SUBJECT: Forwards response to NRC 920213 telcon request for addl info
 re Topical Rept NTH-TR-01, "RETRAN Model Qualification."

L-92-152

Subject: Response to Request for Additional Information
Related to Topical Report NTH-TR-01, RETRAN Model
Qualification - St. Lucie Plant Unit Nos. 1 and 2
and Turkey Point Plant Unit Nos. 3 and 4 (TAC Nos. 75082,
75083, 75084 and 75085)

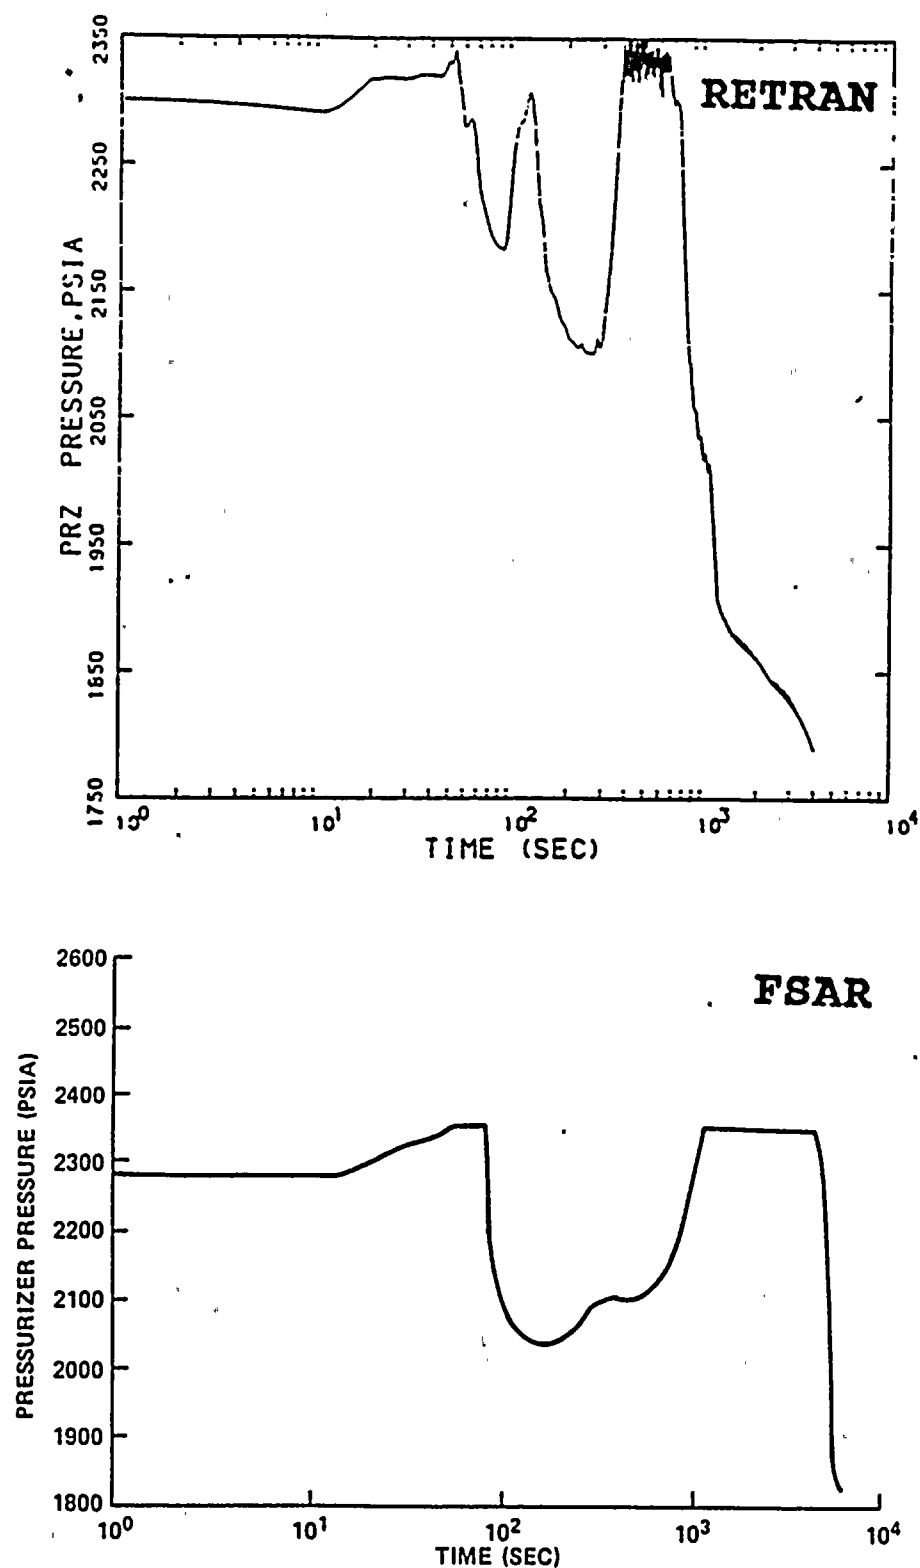
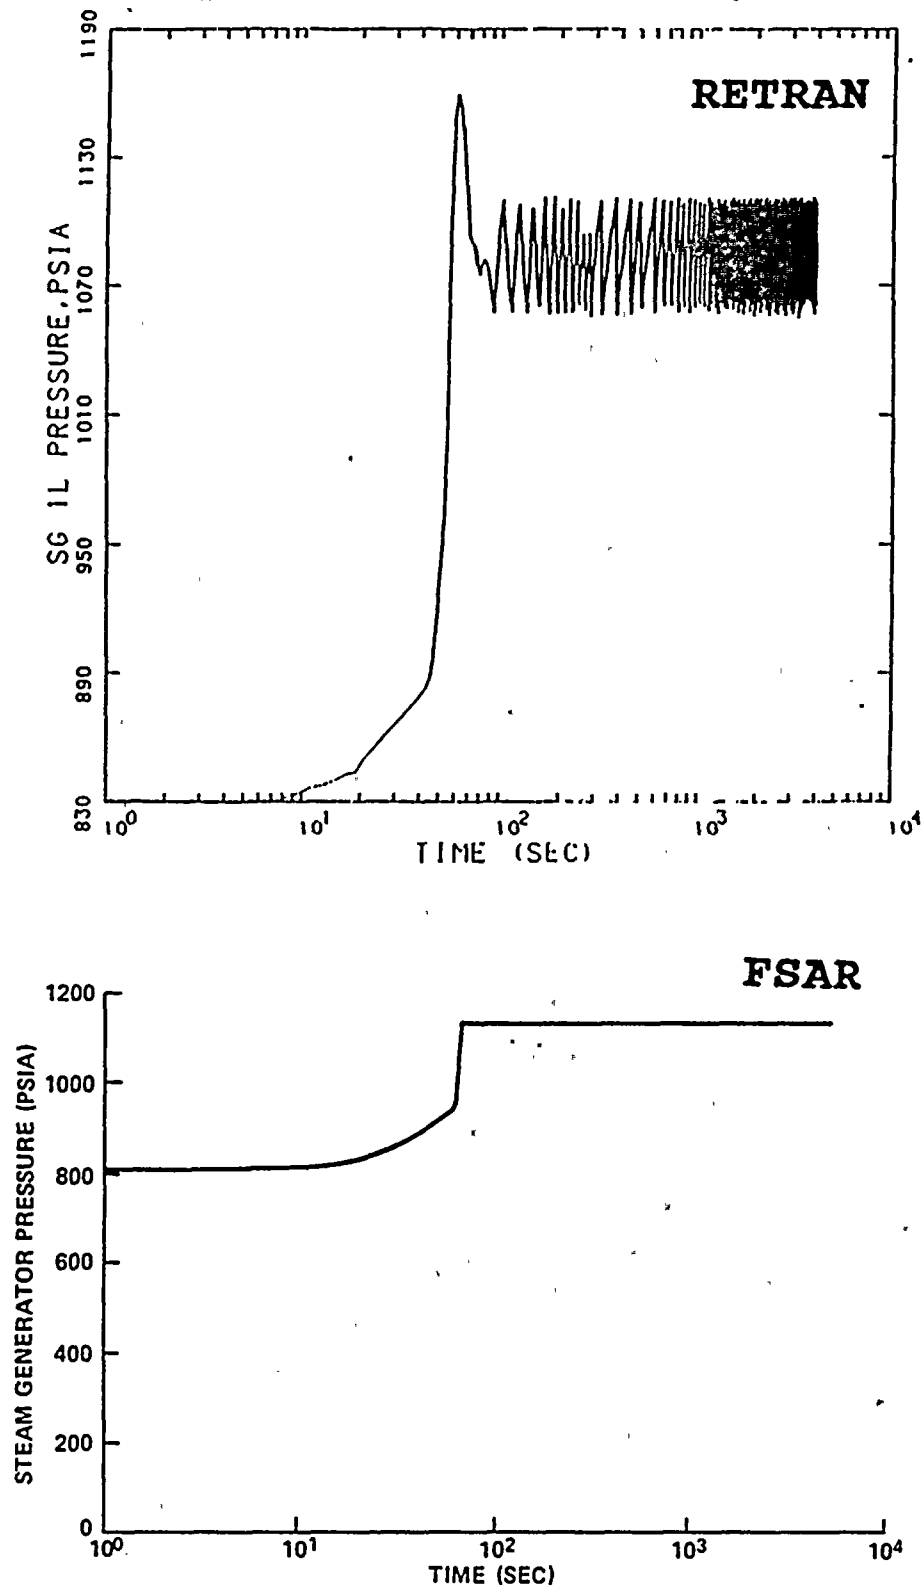
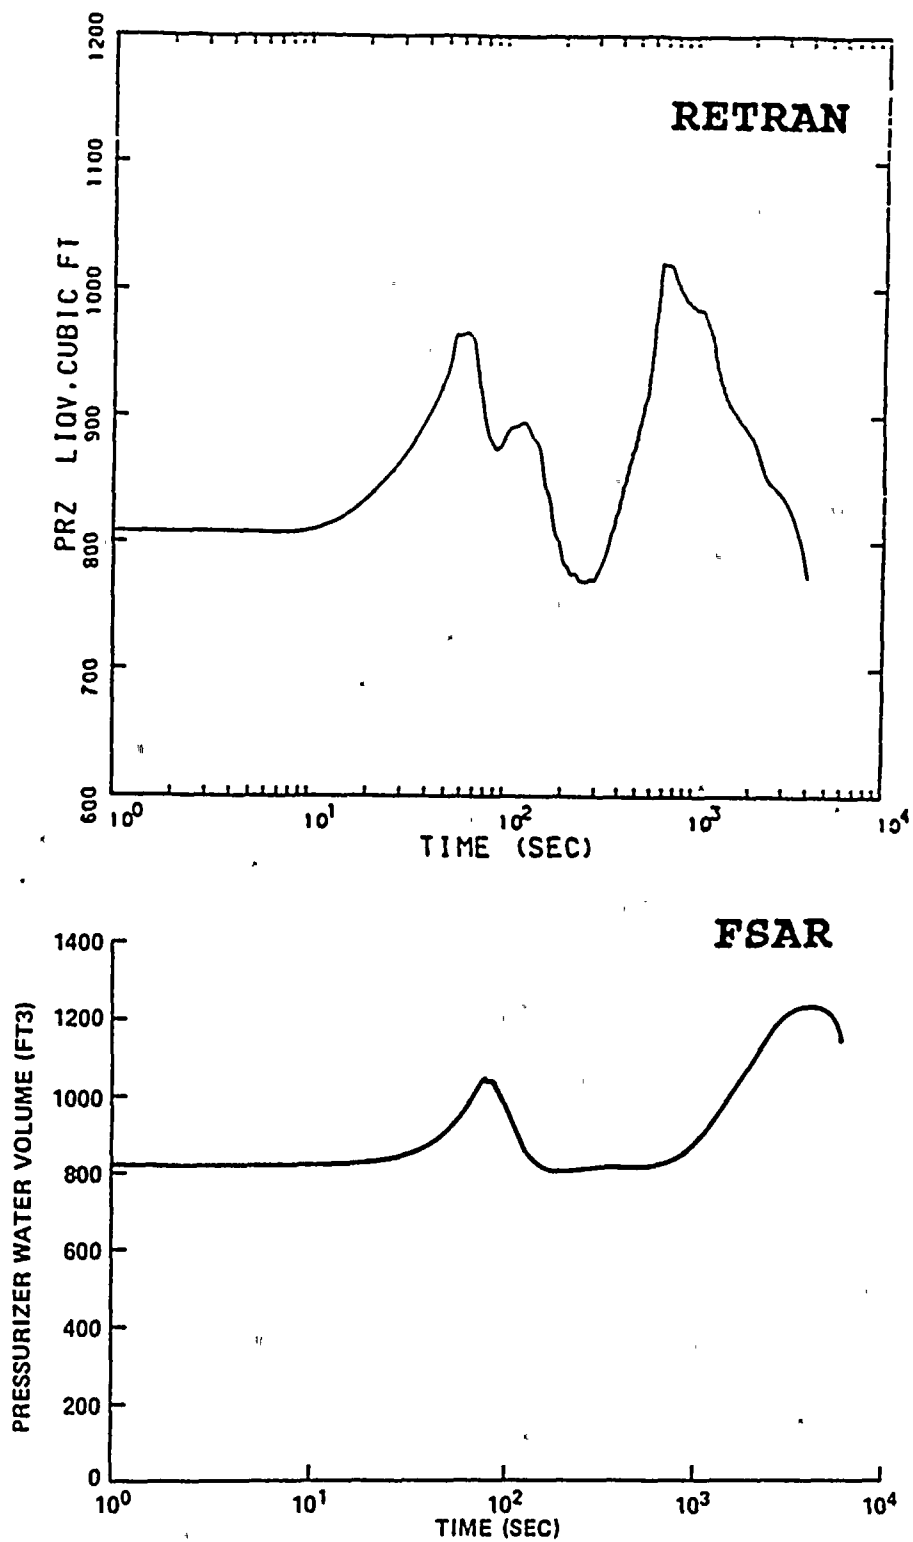
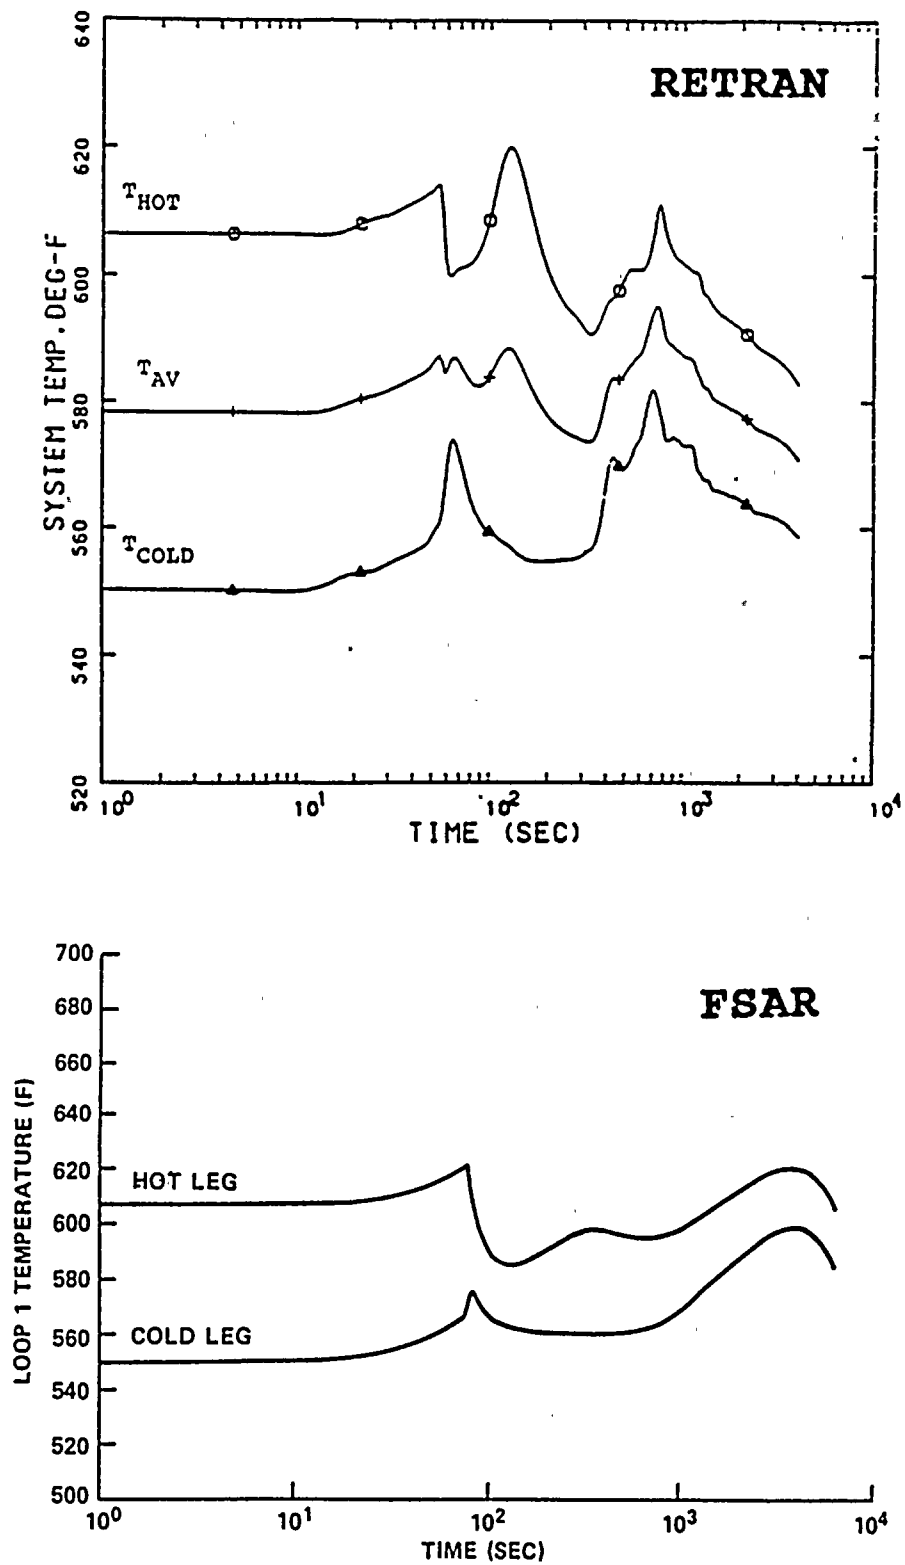
QUESTION: On the RETRAN heatup licensing analyses, provide the following additional information. Discussion should be carefully thought out and thorough. Provide all necessary information (references) to support FPL's conclusions.

- When choosing assumptions/inputs that are different than those in the corresponding FSAR analysis, provide discussion of impact on results.
- Provide FSAR and RETRAN plots for the Turkey Point Loss of AC Analysis and justify the differences.

Figures 1 through 4 show that there is reasonable agreement between the FSAR and RETRAN results. Differences between the two predictions are attributable to differences between LOFTRAN and RETRAN and in large part are due to differences in the way the heat transfer between the primary and secondary systems is modeled in each analysis. The FSAR calculation uses a Single Node Steam Generator (SNSG) model. To overcome the non-conservatism of the overall instantaneous mixing of the auxiliary feedwater fluid in this type of representation, the heat transfer coefficient is artificially altered in the conservative direction. In the FPL

analysis, with the use of a Multinode Steam Generator (MNSG) model, the addition of the auxiliary feedwater fluid is more realistically represented and there is no need for alteration of the code calculated heat transfer coefficients. The different responses predicted by the SNSG and the MNSG models for this transient are described in the (Reference (2) (General Approach Question # 1)).

Differences in the way primary to secondary heat transfer is modeled in each analysis probably explain the different responses to the reactor coolant pumps and turbine trips which happen at about the same time. The resulting cold leg temperature and pressurizer pressure increases are substantially more pronounced in RETRAN than in the FSAR (Figures 1 and 4). Later on, in the RETRAN analysis, the more realistic heat transfer between primary and secondary results in the RCS heatup being turned around shortly after the operator increases the auxiliary feedwater flow from 110 to 230 gpm at 652 seconds.

The results of the LOAC power RETRAN analysis show a peak pressurizer liquid volume of 1020 cu. ft. at 12 minutes after event initiation. Since the actual pressurizer volume at Turkey Point is approximately 1328 cu. ft., there is substantial margin to the water solid condition even with the use of highly conservative assumptions. As discussed in Reference (1), Turkey Point's RETRAN model has been evaluated via benchmarks with plant operational data. Lessons learned from this evaluation have been factored into the development of the RETRAN licensing model used in the LOAC power analysis. Our judgement is that these benchmarks, combined with the use of the conservative assumptions reiterated in this response, provide confidence that FPL can appropriately model the LOAC power transient for Turkey Point and that the results of this analysis will be consistent with acceptance criteria.
